Conway Planning Commission

APRIL 2016 PLANNING COMMISSION ITEMS

CONWAY, ARKANSAS PLANNING COMMISSION MEETING AGENDA

Residence at 43 Mill Pond Road

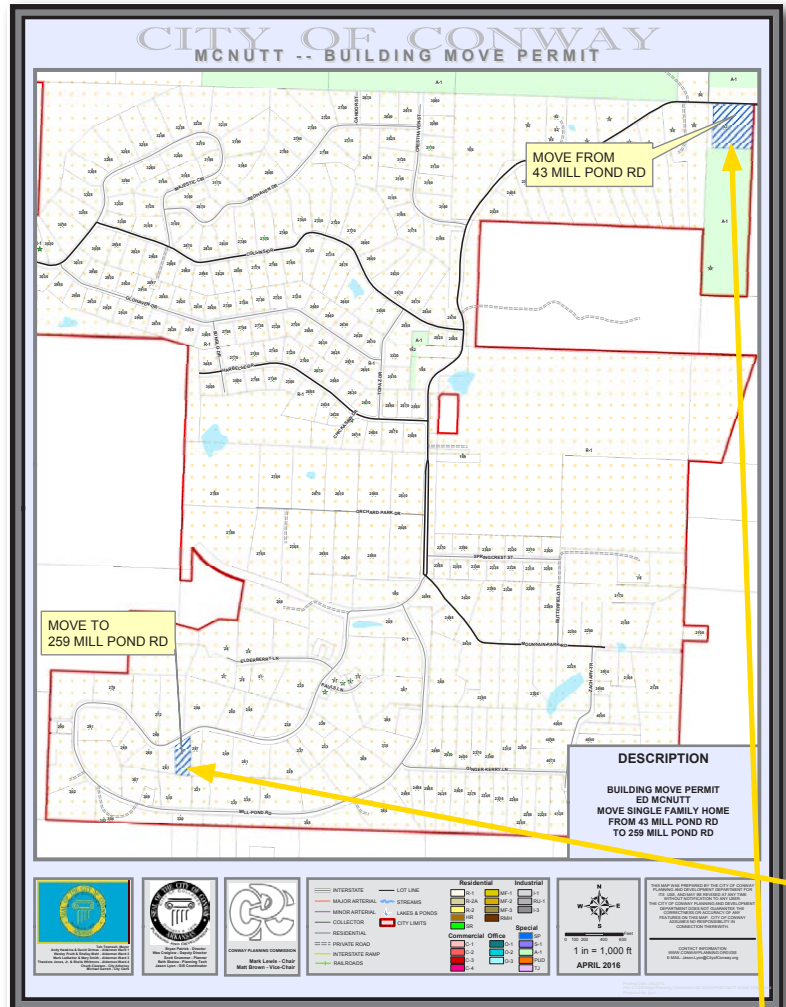
The applicant is seeking a building moving permit to relocate a 1744 s.f. single family residence from 43 Mill Pond Road (4.5 acres) to 259 Mill Pond Road (1.3 acres). A termite inspection is required to show that the structure is sound and safe to move. A report from Central Arkansas Pest Services dated 9-1-2015 stated that the structure was termite free.

There seems to be no issue with moving this single family residence from a large R-1 zoned lot to another large R-1 zoned lot. Planning Staff recommends approval of this building moving permit request.

View of Addition looking NW

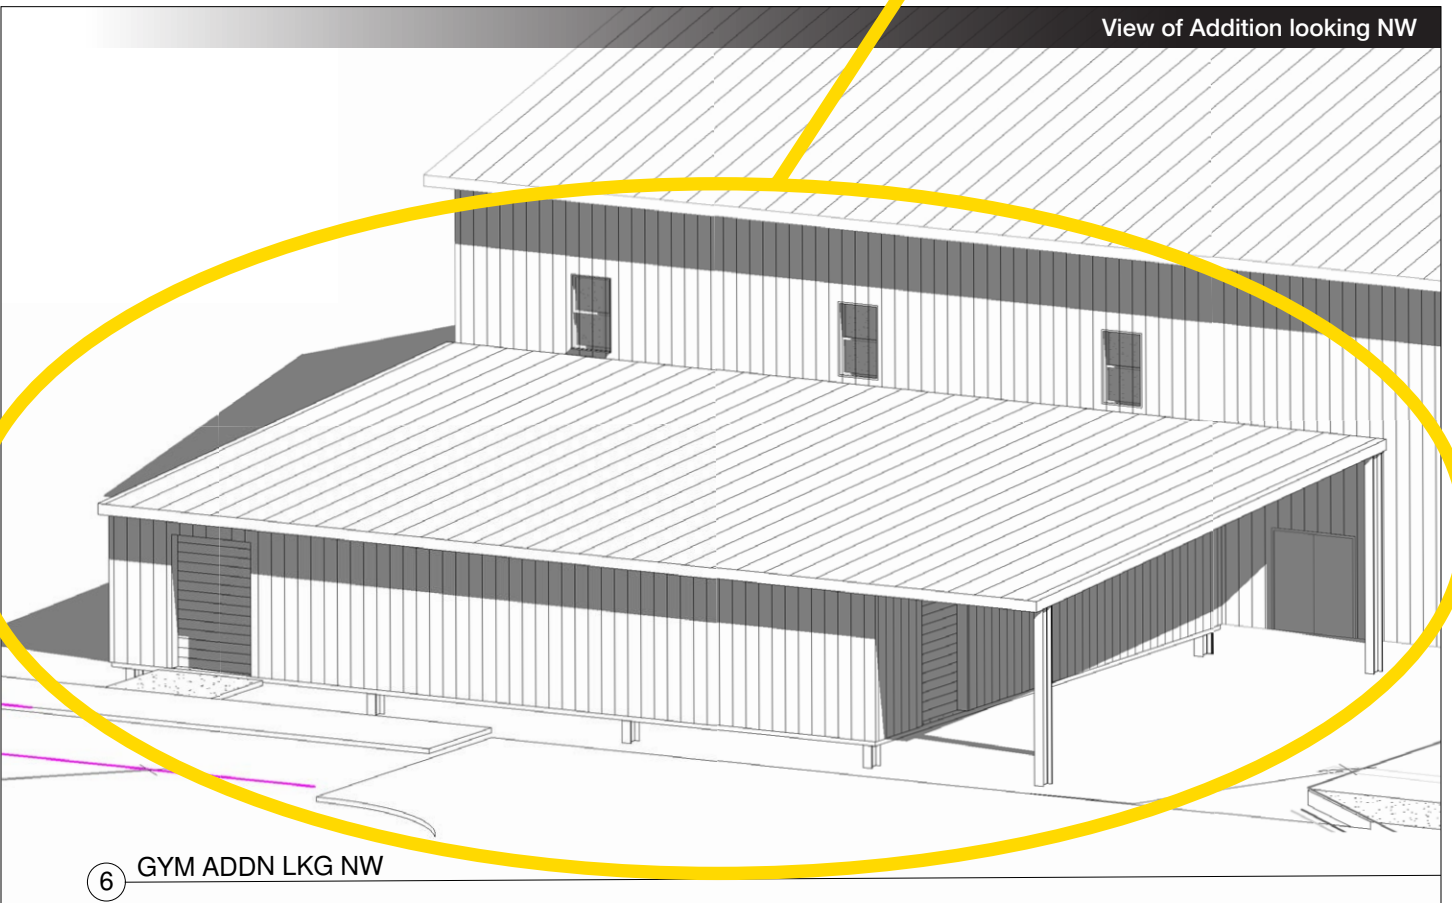
This applicant made a similar request to the Planning Commission in December of 2015 as part of a proposed addition to the east end of their church building. At that time, the Planning Commission denied their appeal. The applicant did not appeal to City Council, instead favoring to meet the city facade requirements and continue on through the permitting process. This current request is regarding a proposed addition to the west end of the same church building.

The Planning Department does not support the complete elimination of the city's facade design standards. There is neither precedence for that action nor would it, in any way, meet the spirit and intent of the building ordinance. The Planning Department staff recognizes that the City Council has been clear and consistent on the enforcement of the city's 50% masonry standard as required by Section 1101.7.C.3.a.ii of the Conway Zoning Ordinance O-94-54, which states *"Masonry shall occupy no less than 51% of any façade of any structure."*

However, in this case, the Planning Department considers a compromise of those standards as a better design choice, due to the pre-existing, non-conforming structure on the site today. This compromise can be justified using Section 1101.7.C.1 of the Conway Zoning Ordinance, O-94-54, which encourages all structures on a site to have a unified design theme. Though the existing structure's façade is non-conforming to current design requirements, the use of canopy trees to screen the large expanse of metal panels and break up the overall mass of the large structure is helpful.

A VARIANCE FROM DEVELOPMENT STANDARD 1101, 7 FOR EXTERIOR CONSTRUCTION MATERIALS TO ALLOW THE CONSTRUCTION OF A METAL SIDED ADDITION AT THE SOUTH SIDE OF THE EXISTING METAL SIDED STRUCTURE. THE 46'-0" x 58'-0" STORAGE ADDITION WILL BE ATTACHED TO AN EXISTING 39'-0" METAL FACADE WHICH IS NOT VISIBLE FROM ANY STREET.

Staff recommends that the façade of the addition should match the façade of the existing structure in both color and material, by type and wall area and therefore a variance be granted per suggested conditions that follow.

- 1. The proposed addition to match those existing design features in color and type, to a reasonable level of +/- 10% of wall area.
- 2. Tree planting around the perimeter of the new building immediately adjacent to the wall, irrespective of the amount of brick installed.
